REMARKS

Attorney Docket No.: **LINDE-581**

FIG. 1

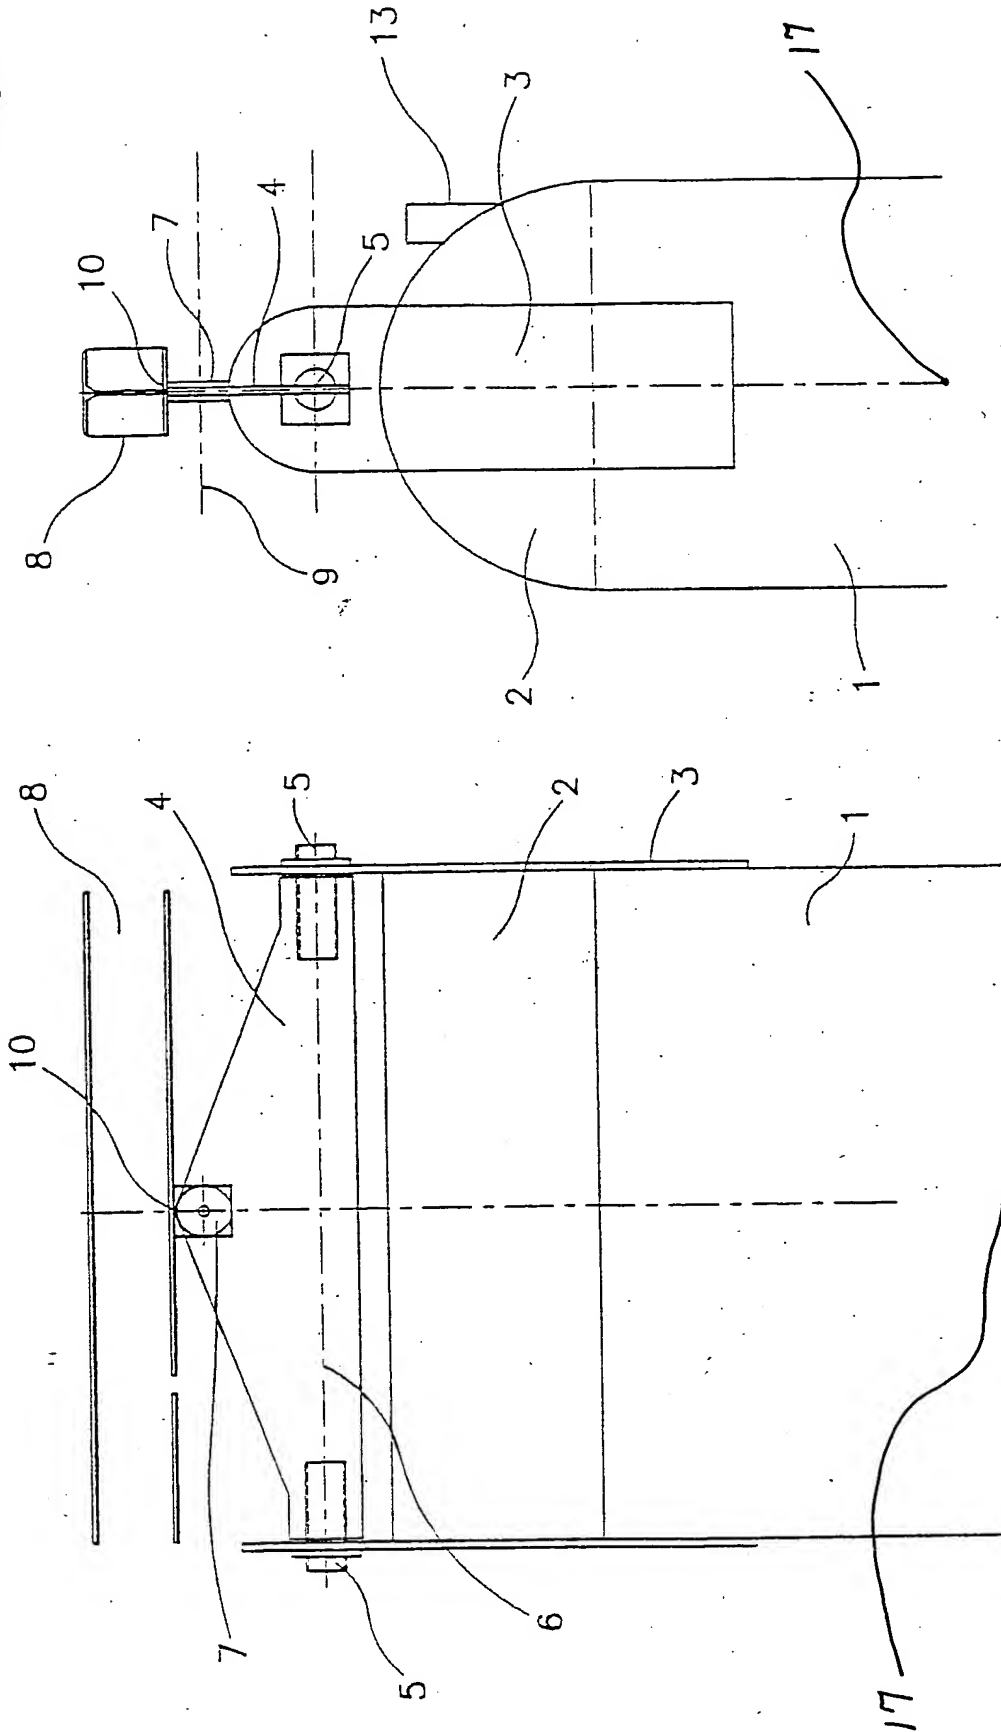
Figures 1 and 2 are amended to show the center of gravity of the heat exchange block, i.e., reference number 17. The specification is amended to provide express reference to reference number 17. The Abstract is amended to delete the term “means” in accordance with the Examiner’s request.

As noted above, attached herewith are Replacement Drawings showing Figures 1 and 2 in which the center of gravity 17 is explicitly shown. However, applicants respectfully submit that this change to the drawings is unnecessary. The center of gravity is an inherent feature of any object having mass. One of ordinary skill in the art would readily recognize that the heat exchange block illustrated in the figures would have a center of gravity. Since one of ordinary skill in the art can readily recognize that the object inherently has a center of gravity, it is unnecessary to illustrate this concept.
